## **IX. RESPONSES TO COMMENTS ON THE DRAFT EIR**

## **COMMENTS RECEIVED FROM LARWQCB – NOVEMBER 5, 2007**

Figure IX-1  
Working Draft Site Plan  
Proposed Project

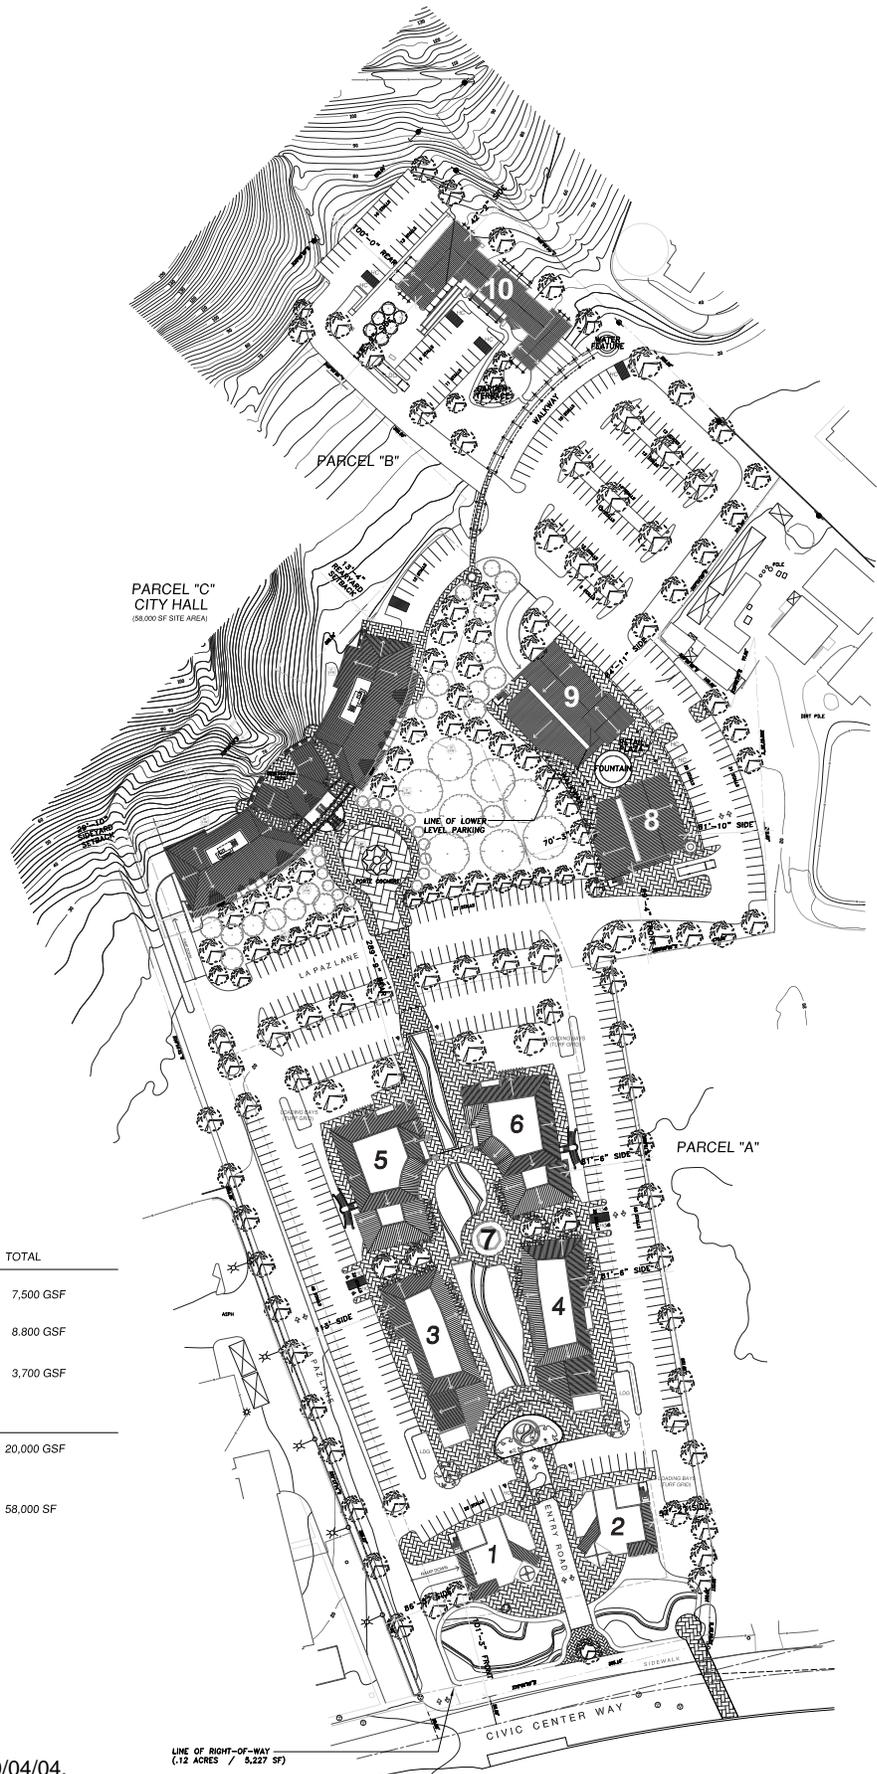
Lack of Adequate Mitigation Measures to Prevent Noise, Light and View Blockage From buildings 10 and 11 on Parcel B

Buildings 10 and 11 on Parcel B are located in very close proximity to the Gustavson residence. They are the only structures in the proposed project that is in close proximity to existing residence. Accordingly, mitigation measures for these structures should be greater, because the impacts of that structure are likely to be greater to the project's neighbors, i.e., the Gustavson's, than structures that do not abut existing residential development. As presently designed, Building 10 will have two levels totaling 7,258 square feet. Building 11, which is set back further from the Gustavson's property and more landward, is only 4,863 square feet. Fifteen parking spaces are located on the property line dividing the La Paz Ranch

property and the Gustavson property. Those spaces are at an elevation approximately 12 feet higher than the elevation at the front of building 10 and will be accessible via driveways which have an incline in elevation. Vehicles entering this parking area at night would shine their headlights onto the Gustavson residence. Vehicles parking in this area would produce noise and exhaust which could be significant given the proximity of these parking spaces to the Gustavson residence.

These impacts are significant to the Gustavsons, and should have been addressed in the DEIR. Proposed mitigation measures are likewise absent from the DEIR. For example, the locations of buildings 10 and 11 could be switched, along with the parking required for those buildings, so that the larger building is located further from existing residential development. Likewise, the relocation of parking spaces away from the property line might decrease the impacts created by building 10. These mitigation measures, and others proposed by the Developer, should be addressed prior to certification of a final EIR.
